Service Bulletin

**SUBJECT: Service Update for Inventory Vehicles Only
Turn Signal May Not Automatically Cancel**

MODELS: 2013 Cadillac XTS

3401815

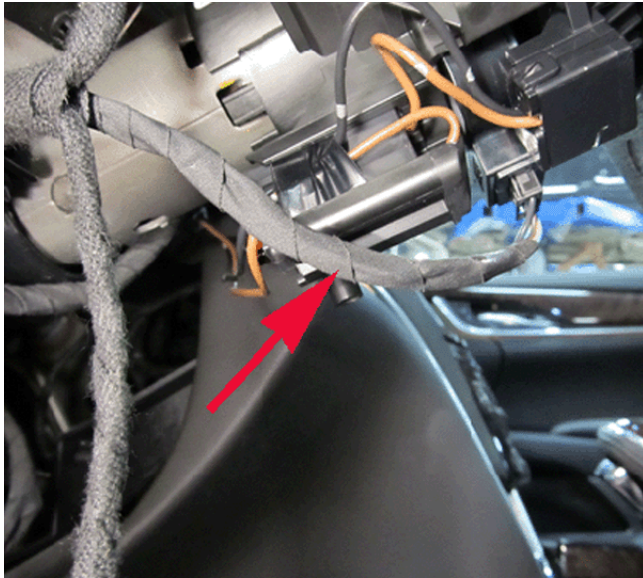
Note: The steering column wiring harness may be causing the Steering Angle Sensor (SAS) to interfere with the self-cancel mechanism of the turn signal. If the wiring harness (1) is routed on the outboard side of the column trim mounting pedestal (2), it may put strain on the 6 way SAS connector (3) causing the SAS to interfere with the turn signal cancel pawl. This interference cannot be seen. It is on the steering wheel side of the SAS. Refer to the service procedure below to reposition the steering column wiring harness and relieve the strain on the 6-way connector.

3401823

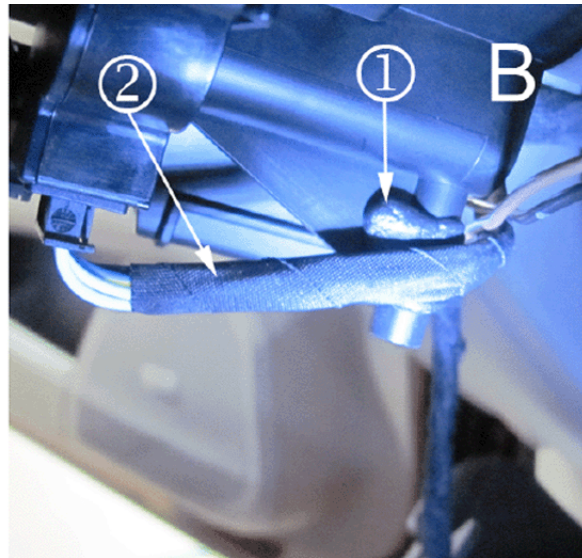
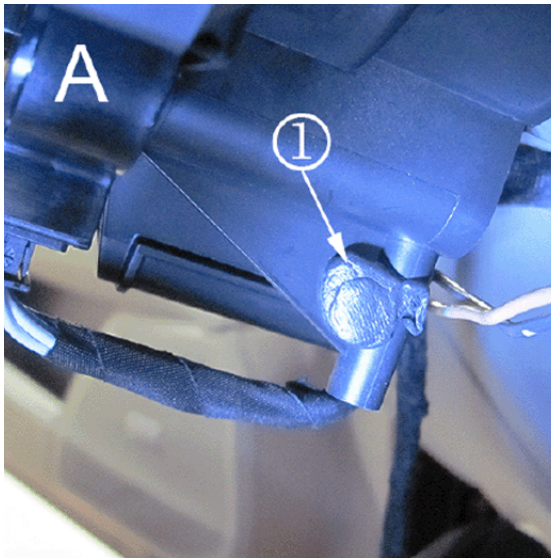
2. Locate the steering column wiring harness connected to the 6-way Steering Angle Sensor (SAS) connector.

3. Position the steering column wiring harness (2) to the inboard side of the column electrical assembly (CEA) mounting pedestal (or right hand side from the center of the column assembly) as shown in the 'B' portion of the photograph. This step is required to route the harness in its natural form on the right hand side first.
4. Roll a 12mm (1/2 in.) piece of Kent Industries butyl tape or an equivalent butyl tape into a marble size ball.

5. Install the butyl (1) tape at the base of the column electrical assembly (CEA) mounting pedestal on the right hand/inboard side as shown in the 'A' portion of the photograph.
6. With the steering column wiring harness in the correct position, push the wire bundle into the butyl material (1) to keep the harness in position during re-installation of steering column lower trim cover. Refer to the 'B' portion of the photograph.
7. Reinstall the steering column lower trim cover. Refer to Steering Column Lower Trim Cover Replacement in SI.
8. Road test the vehicle to verify the turn signals self-cancel and to re-establish the steering angle sensor communication.
